Re: Workplan-Proposal for Soil and Groundwater Investigation Services at  
5293 Crow Canyon Rd., Castro Valley

RE: SOIL CONTAMINATION AT 5293 CROW CANYON ROAD, CASTRO VALLEY:  
REQUEST FOR PRELIMINARY SITE ASSESSMENT

RE: SOIL/GROUNDWATER WORKPLAN PROPOSAL, 5293 CROW CANYON RD.,  
CASTRO VALLEY

4. Site Plan at 5293 Crow Canyon Road, Castro Valley

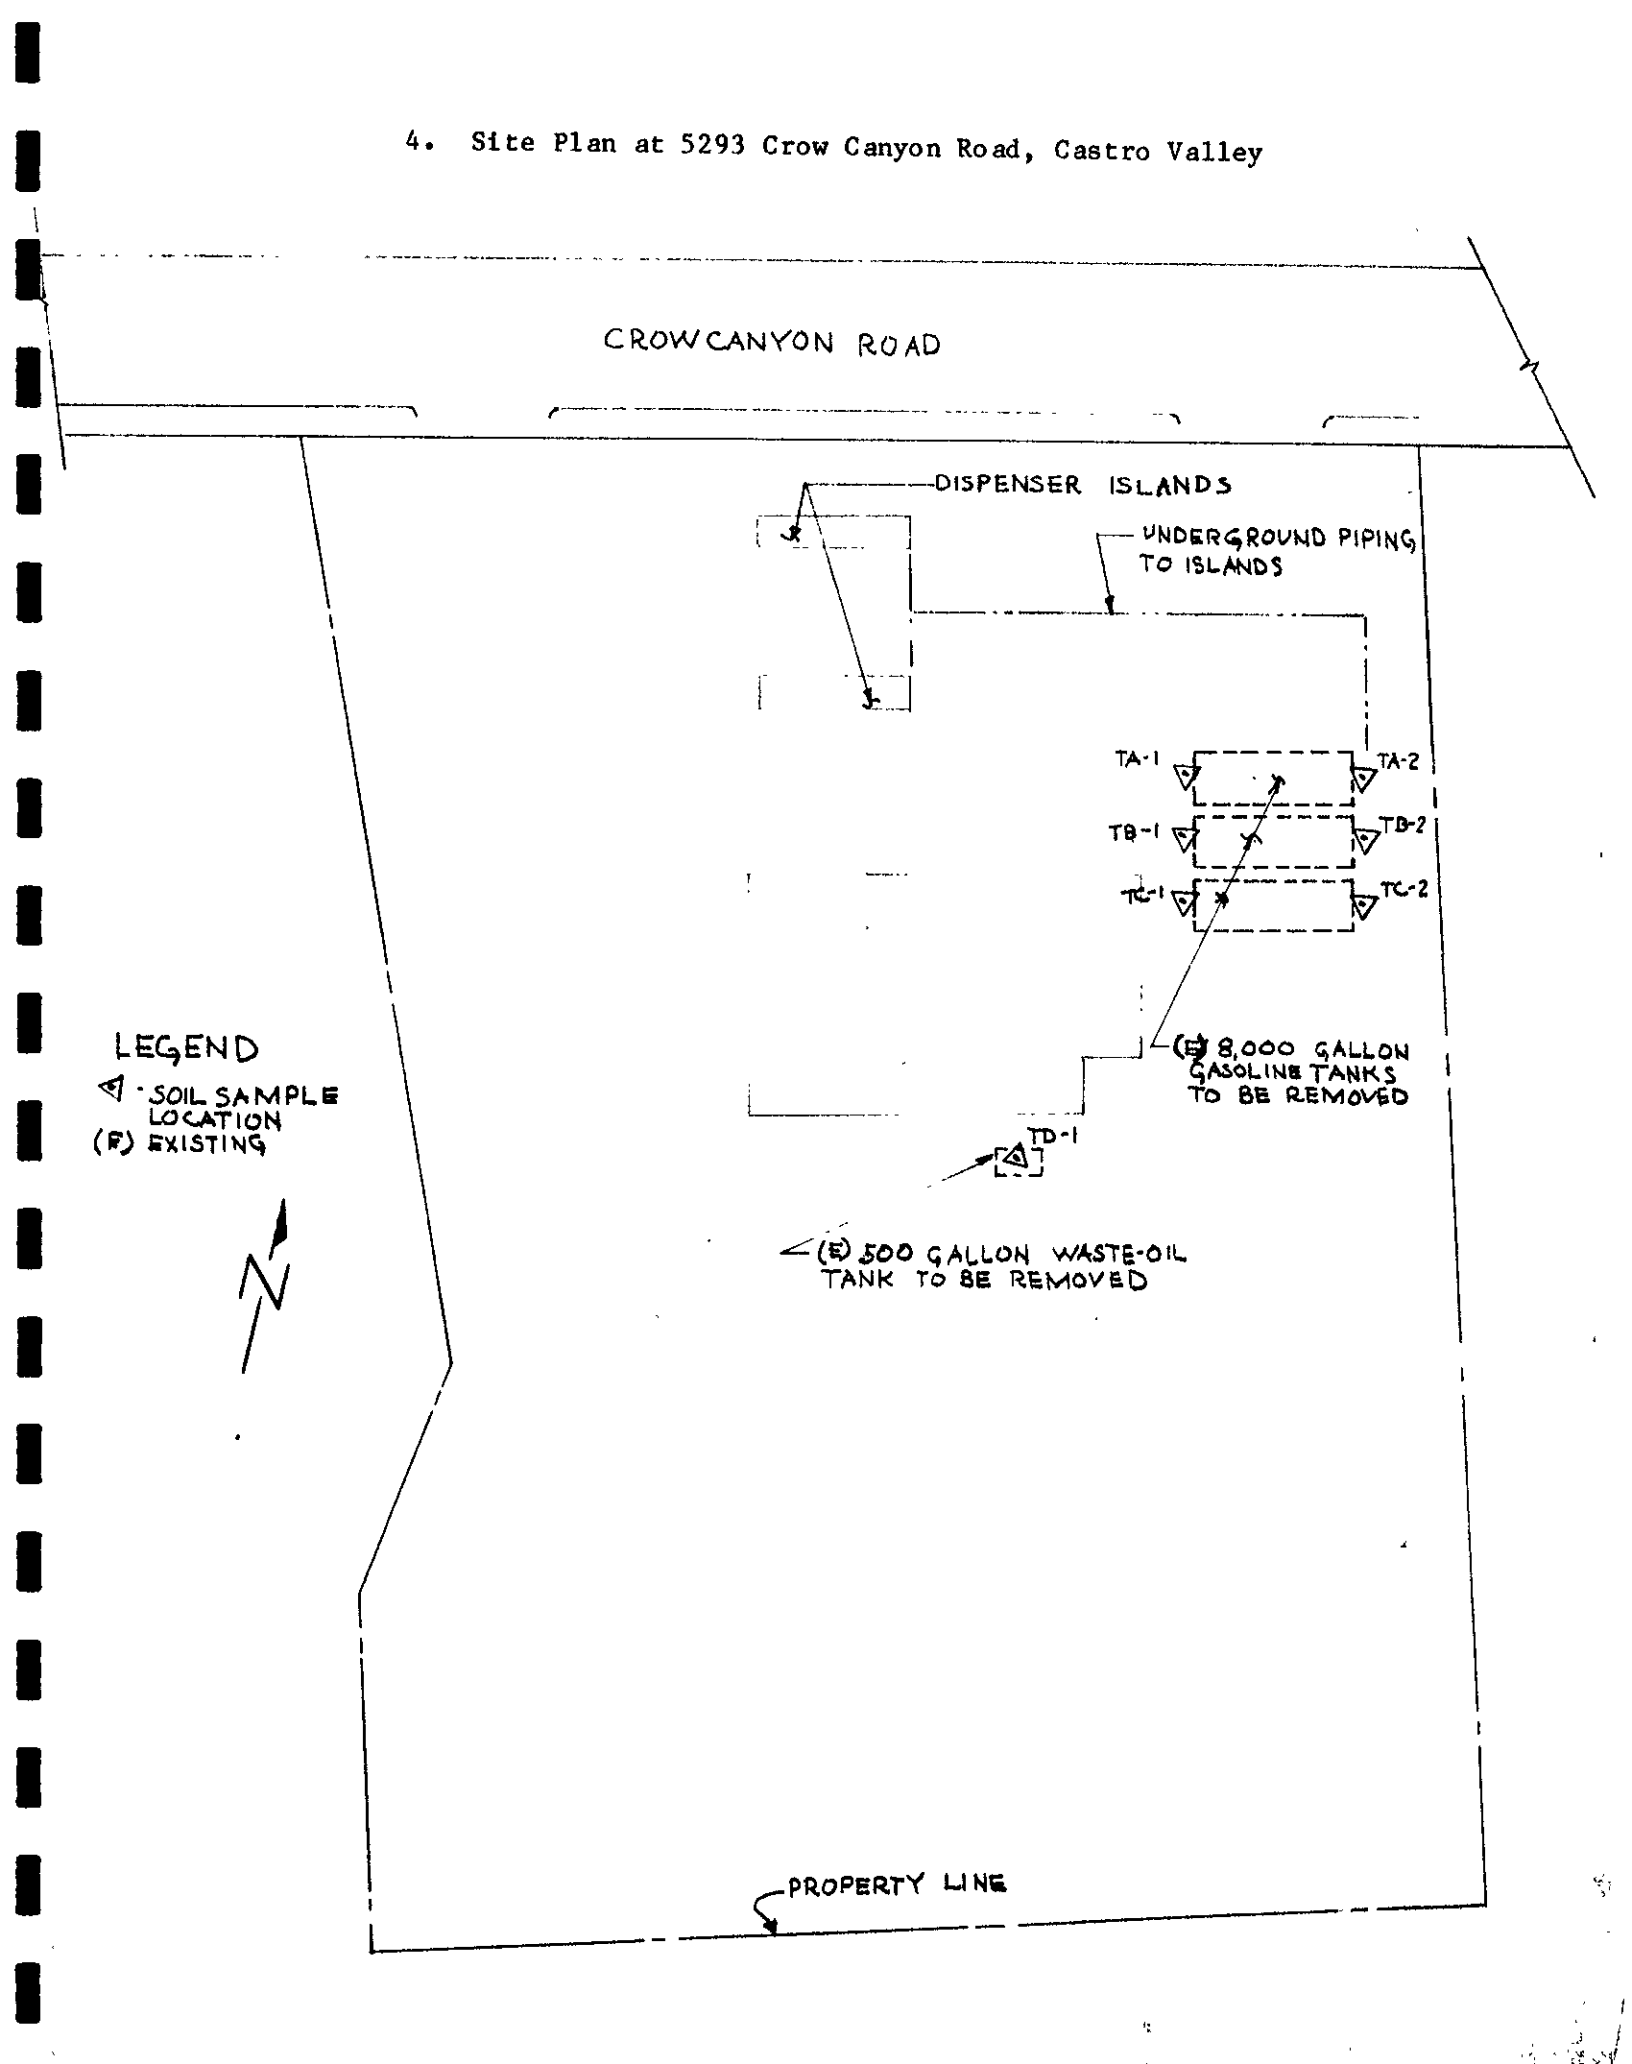
- 1) All reports and proposals must be submitted under seal of a California-Registered Geologist, -Certified Engineering Geologist, or -Registered Civil Engineer. Include a statement of qualifications;
- 2) The locations of proposed borings 4, 5, 6, and 7 are not clear. Section III, A/B of the report conflicts with the schematic representation of boring locations as depicted in Figure 2;
- 3) Provide a well construction diagram. Presumably, the referenced "Figure 4" (Sec. IV, B) is such a diagram but was not included with this submittal;
- 4) Based upon local topography and surface drainage in proximity to the site. the approximate groundwater flow direction is presumed to be to the southwest, or towards Crow Creek. Therefore, it is recommended that the location of proposed monitoring well MW-1 be moved approximately 25-35 feet to the

south-southwest from its current location. This will place MW-1 somewhat southwest of the southern-most dispenser island, potentially better suited to identify contaminants in groundwater derived from leaks beneath, or in proximity to, either dispenser island;

Upon encountering groundwater at less than 45 feet drilling depth, a monitoring well (MW-1) will be drilled to a maximum of 65 feet and installed about 25-35 feet southwest of the dispenser islands. MW-2 will be placed near the southwest corner of the gasoline tank pit. MW-3 will be located within 5 feet of the waste oil tankpit. If groundwater is not encountered, the borings will backfilled with Portland cement pumped through a tremmie hose from 45 feet depth up to original grade.

Upon encountering groundwater at 45 feet depth or less, MW-1 will be installed to 65 feet maximum depth about 25-35 feet southwest of the pump islands. MW-3 will be drilled and installed as MW-1 within 5 feet of the waste oil tankpit, with MW-2 established on the southwest corner of the gasoline tankpit. The three wells are located to allow good triangulation of survey points in a groundwater gradient determination, as well as to obtain sample points from specific areas of concern, as noted above.
